10.2 Turbine Generator

The information in this section of the reference ABWR DCD, including all subsections, tables and figures, is incorporated by reference with the following departures and supplements.

Figure 10.2-1 Turbine Stop Valve Closure Characteristic

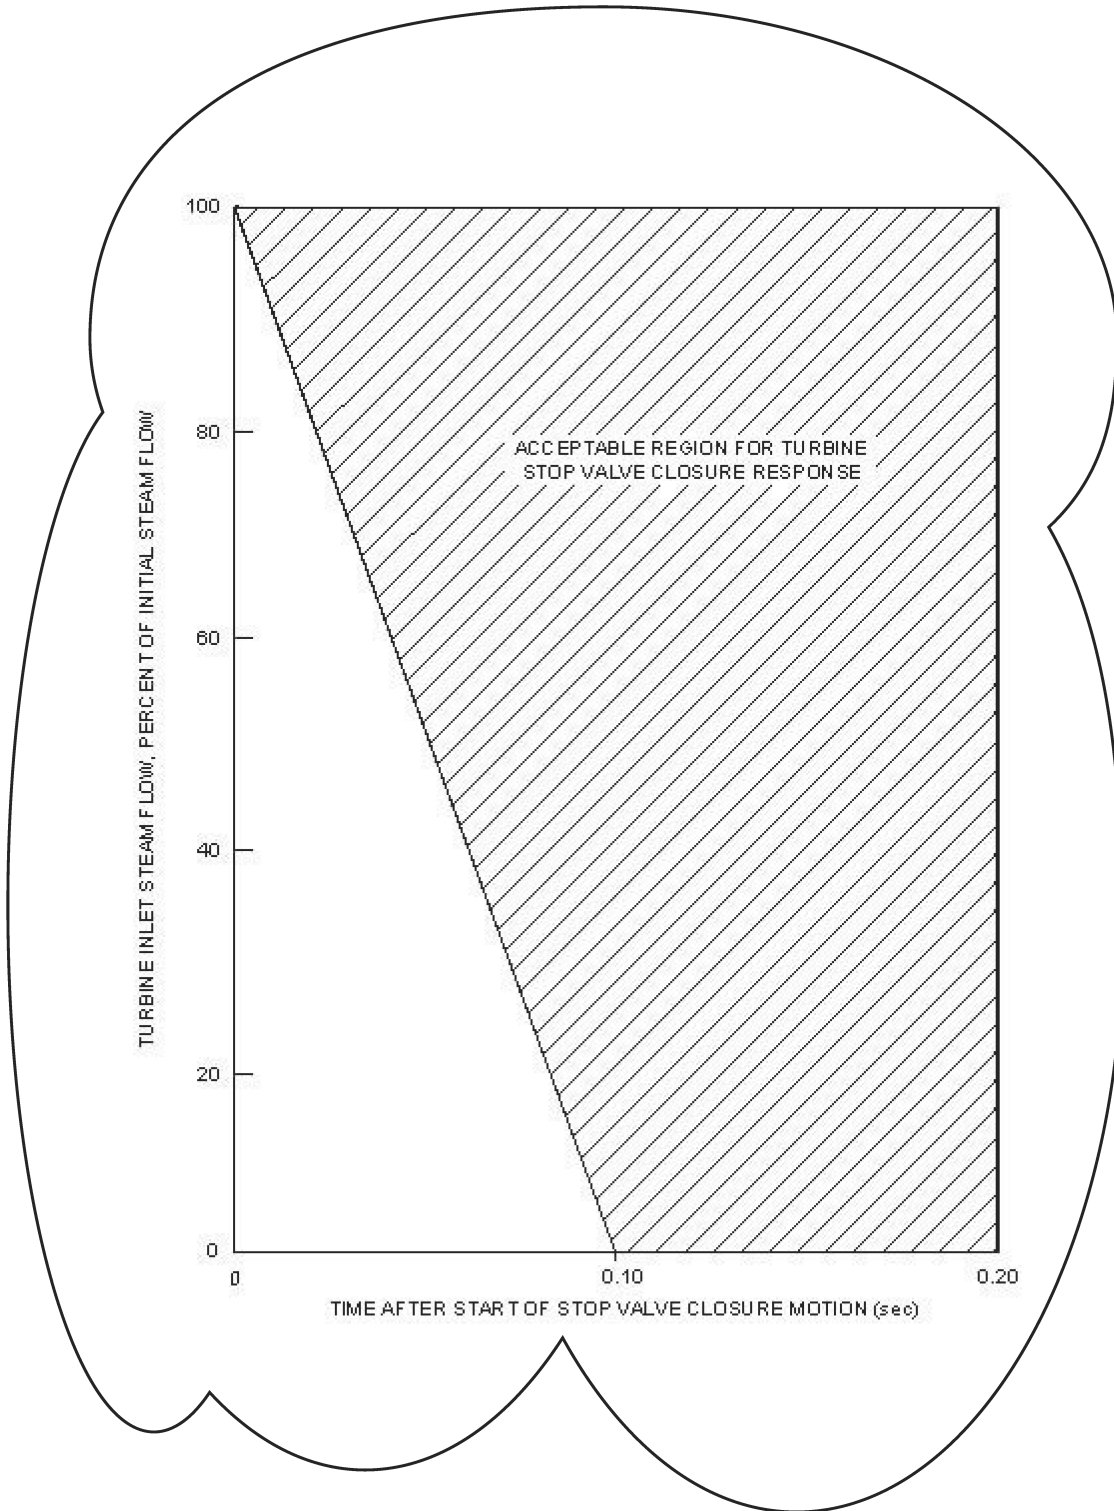
STD DEP Admin (Figure 10.2-1)

Figure 10.2-4 Generator Hydrogen and CO₂ System

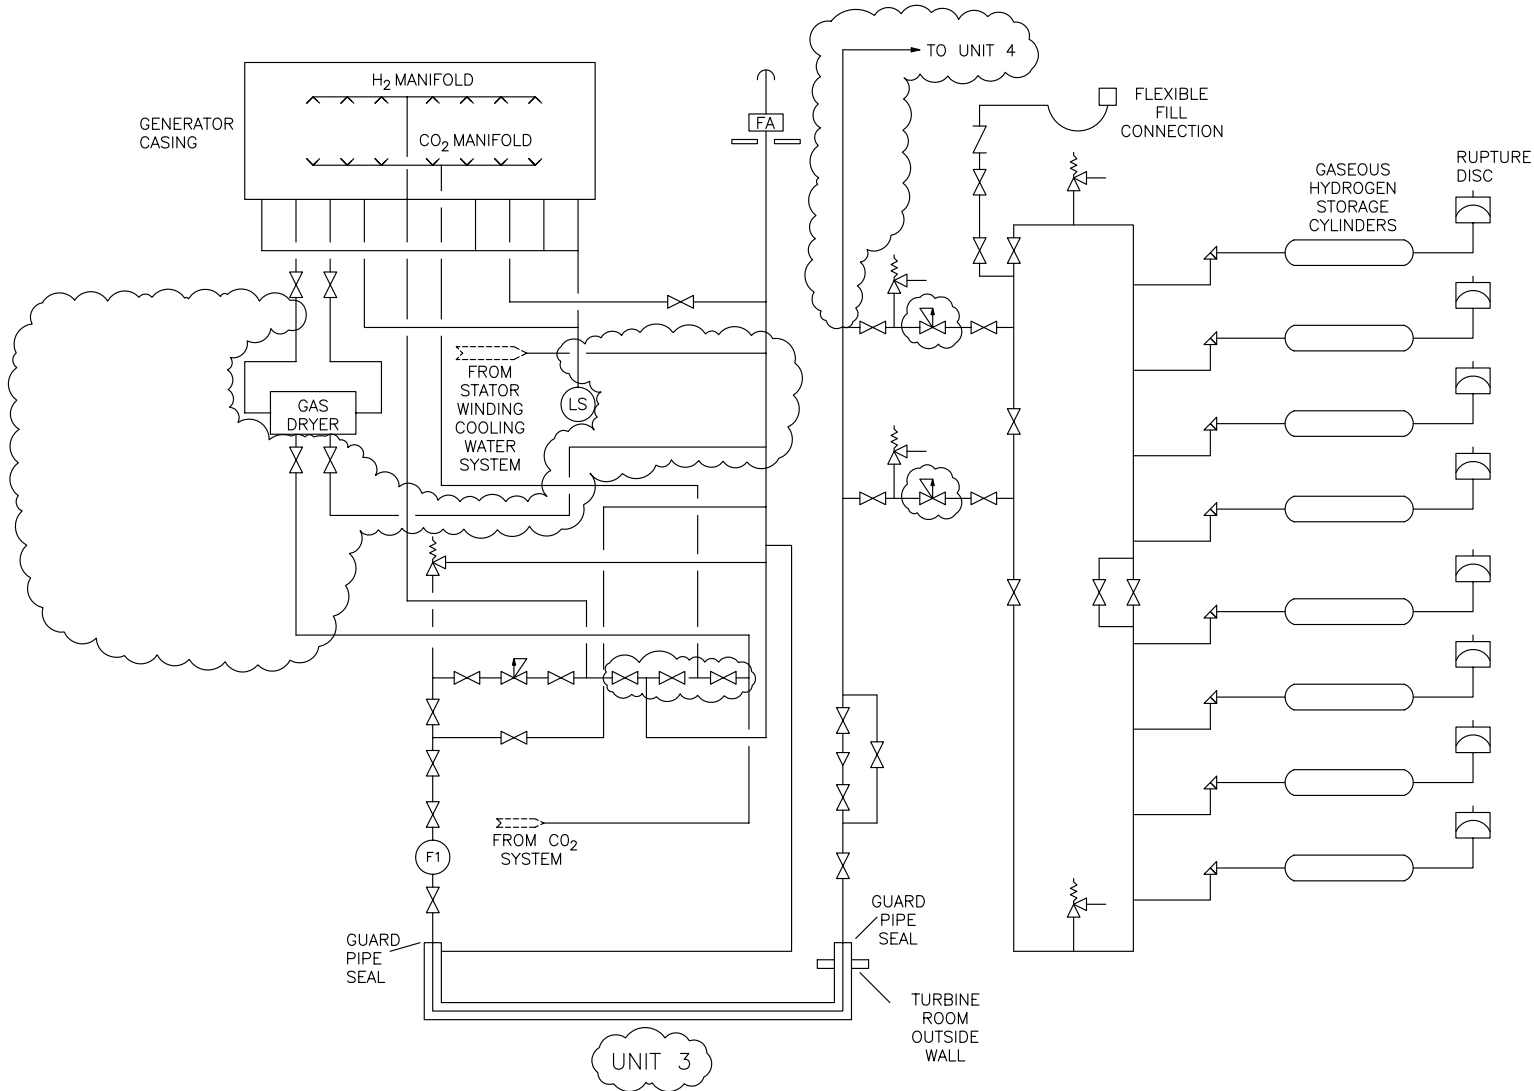
STP DEP 1.1-2 (Figure 10.2-4)

STP DEP 10.2-1 (Figure 10.2-4)

Bulk Hydrogen System—*The bulk hydrogen and CO₂ system is illustrated on Figure 10.2-4. The hydrogen system is designed to provide the necessary flow and pressure at the main generator for purging carbon dioxide during startup and supply makeup hydrogen for generator leakage during normal operation.*

Figure 10.2-5 Turbine Overspeed Trip System Functional Diagram

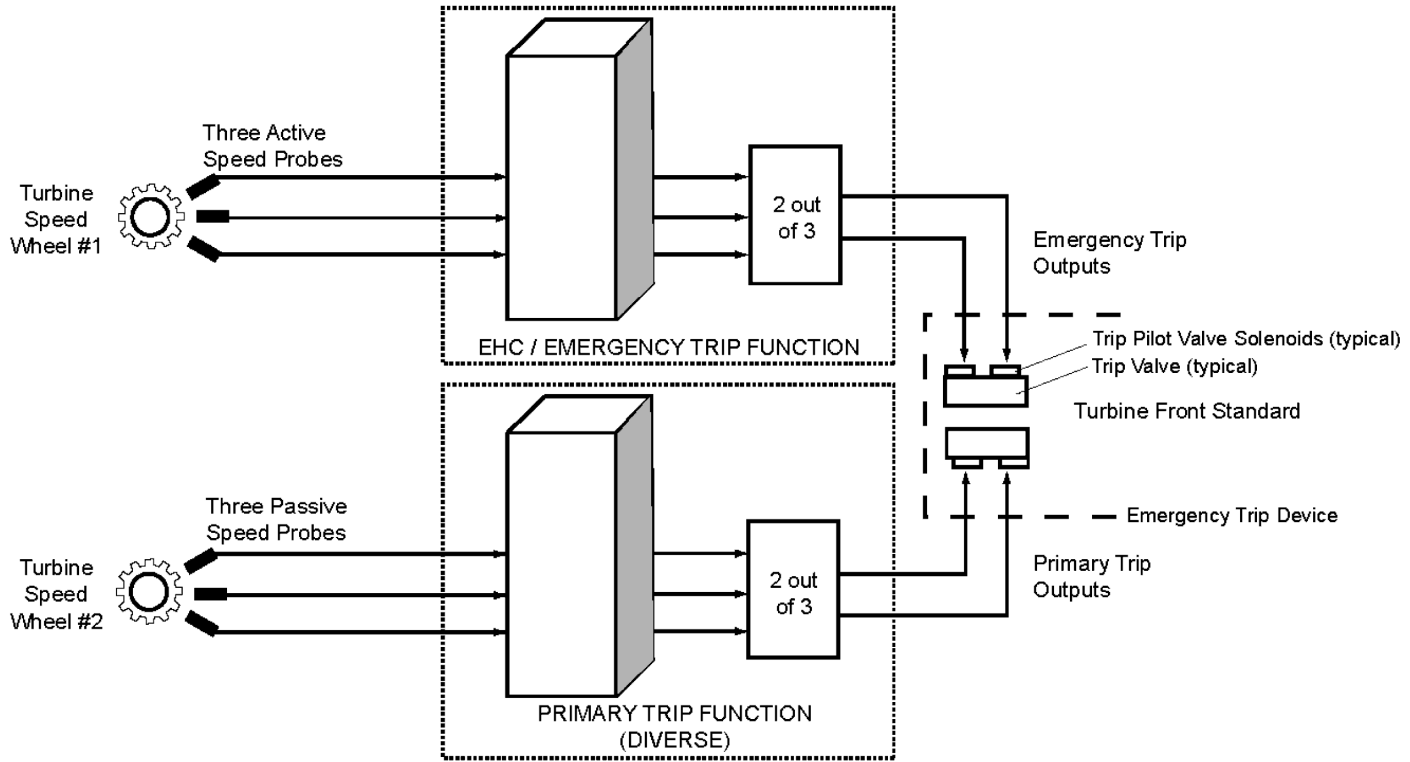
The primary trip function is independent and diverse from the emergency trip function as explained below (refer to Figure 10.2-5, Turbine Overspeed Trip System Functional Diagram). Two-out-of-three logic is employed in both the primary and emergency overspeed trip circuitry. Each trip function can de-energize its associated trip pilot valve solenoids of the electro-hydraulic Emergency Trip Device (ETD). The ETD is composed of two independent trip valves, each with two normally energized fail-safe solenoids. For each trip valve, each trip pilot valve solenoid is powered from a separate power source. The solenoids de-energize in response to detection of an overspeed condition by the turbine speed control logic. De-energization of both trip pilot valve solenoids is necessary to cause the spool in their respective trip valve to reposition, which depressurizes the emergency trip fluid system, rapidly closing all steam inlet valves and indirectly closing the steam extraction nonreturn valves. Accordingly, the repositioning of only one of the two trip valves is necessary to trip the main turbine. A single electrical component failure does not compromise trip protection, and does not result in a turbine trip. Each trip valve in the ETD is testable while the turbine is in operation.

The diverse primary overspeed trip function utilizes three passive speed sensors that are separate from the active speed sensors used for normal speed control and emergency trip function. Speed sensors are diverse (passive and active sensors) between primary overspeed and emergency overspeed trip. Speed sensing for primary

and emergency overspeed trip functions also use separate speed wheels (refer to Figure 10.2-5). Each speed signal for the primary trip function is compared to a speed setpoint of approximately 110% of rated speed, and produces trip signals arranged in two-out-of-three logics, to de-energize both trip pilot valve solenoids of one of the two trip valves of the ETD. Both trip pilot valve solenoids must be de-energized to trip the associated trip valve. The ETD has two redundant trip valves. Tripping of either redundant trip valve will drain the emergency trip fluid, resulting in a turbine trip.
